The Commission has issued the enclosed Amendment No. 31 to Provisional Operating License No. DPR-20 for the Palisades Plant. The amendment consists of changes to the Technical Specifications and is in response to your request dated August 12, 1977, as supplemented September 26, 1977.

This amendment authorizes operation of the Palisades Plant at power levels up to 2530 megawatts thermal.

AMENDMENT TO PROVISIONAL OPERATING LICENSE

ATTACHMENT TO LICENSE AMENDMENT NO. 31  
PROVISIONAL OPERATING LICENSE NO. DPR-20  
DOCKET NO. 50-255

**Figure  
3-9**

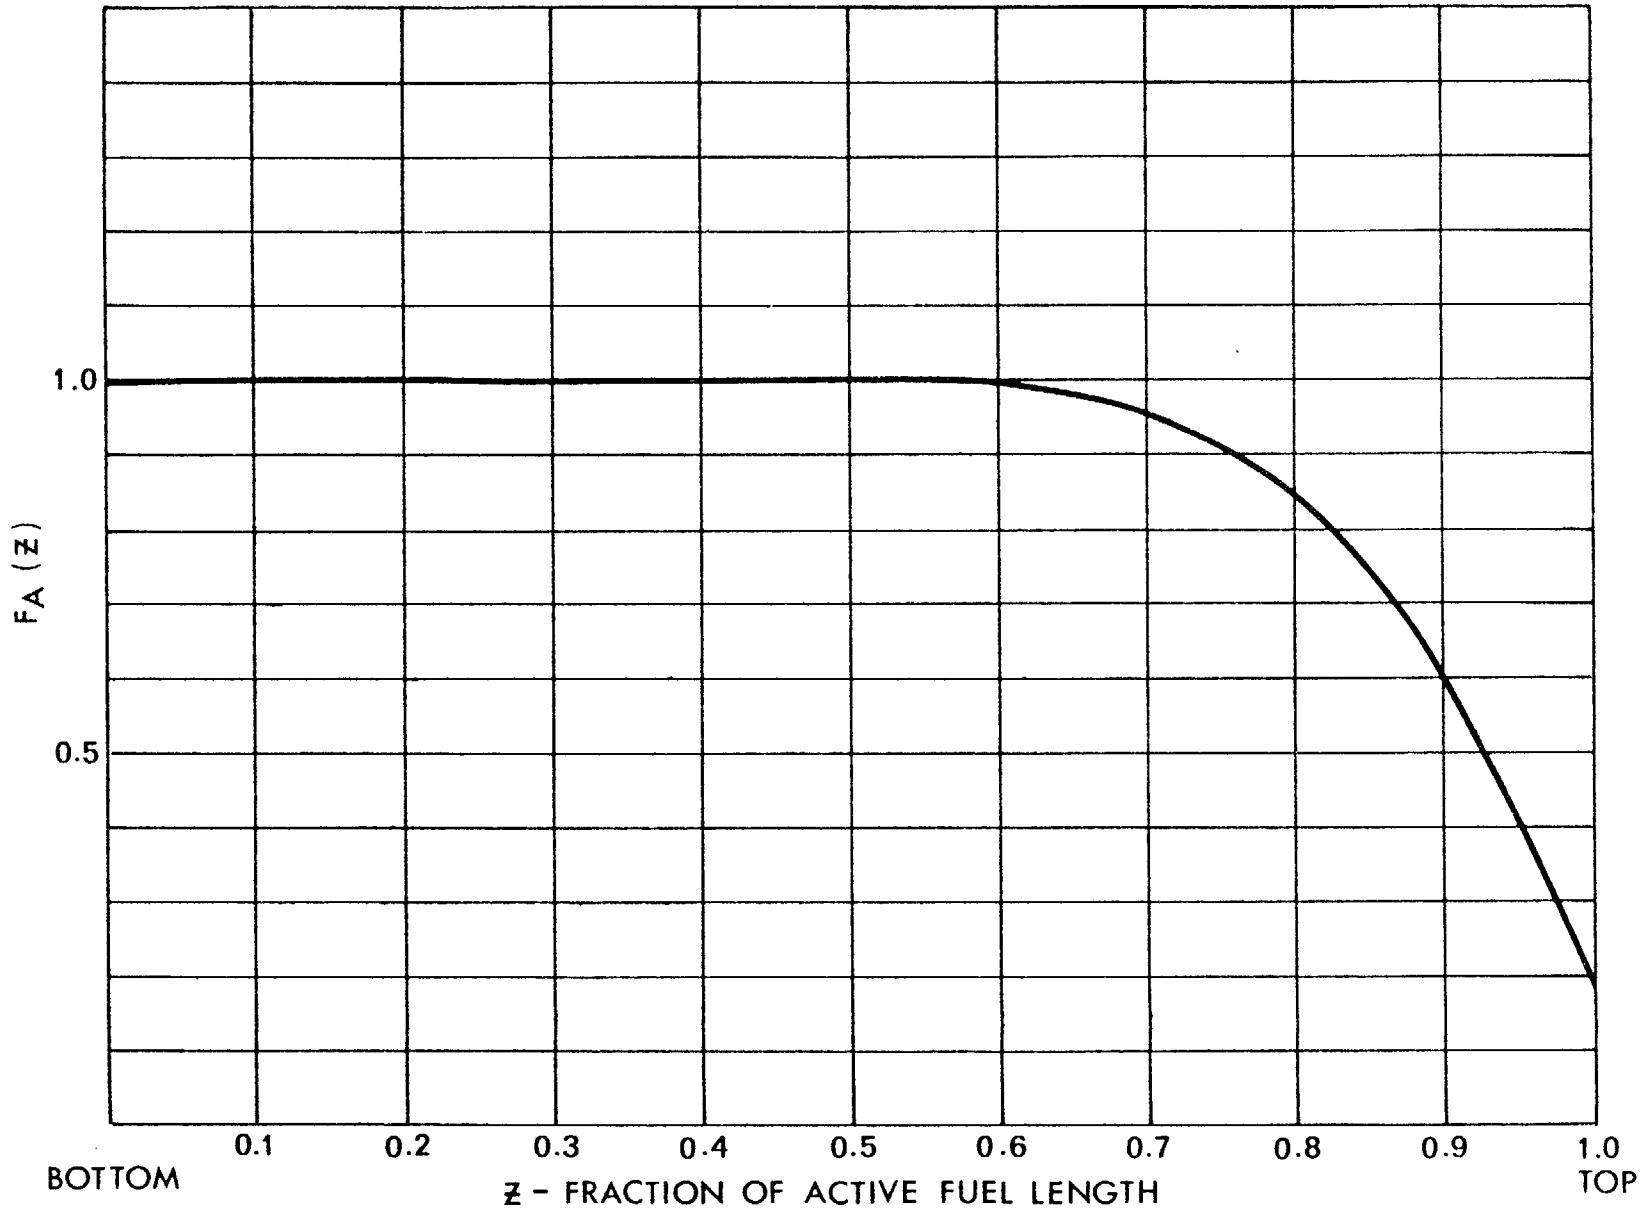
Sec. 3.10.3 (p3-58, 59, Fig 3-9) The Power Distribution Limits have been modified for 2530 Mwt operation. PLHGR is consistent with the LOCA analysis and an axial power distribution term has been provided which replaces the upper to lower half of the core power ratio.
